Notes for Rev Changes:

Accelerometers

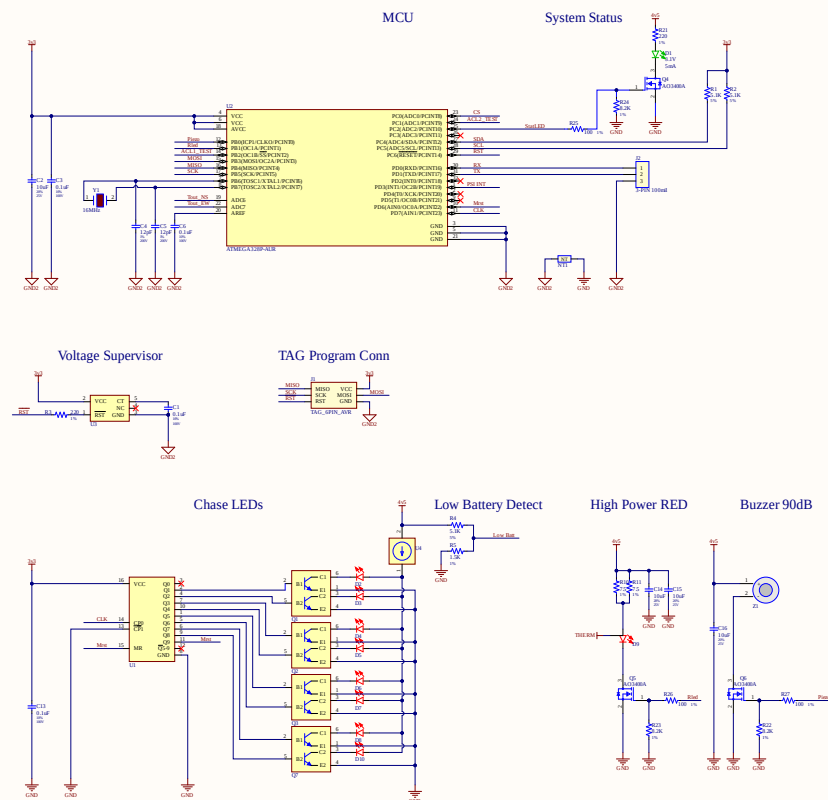
- Decade Counter CP1 to GND
- Remove Q4 and cpm net not used
- added current limit R to Status LED
- replace Q5 and Q6 with more appropriate Transistors - Old part TIG058B-TL-H - New AC3400A
- REV1.3:
- Decade Counter, moved off Q0 so LED does not stay on.
- Removed RGB LED
- Added in green LED circuit in place of RGB
- Layout updates with above and some small changes to nets.
- Added protection resistors to I/O On Buzzer and HPLED
- REV1.4:
- Added 3 Axis Accel (x2)
- Updated board cuts for Z-NS and Z-EW Accelerometers to install from bottom of the board
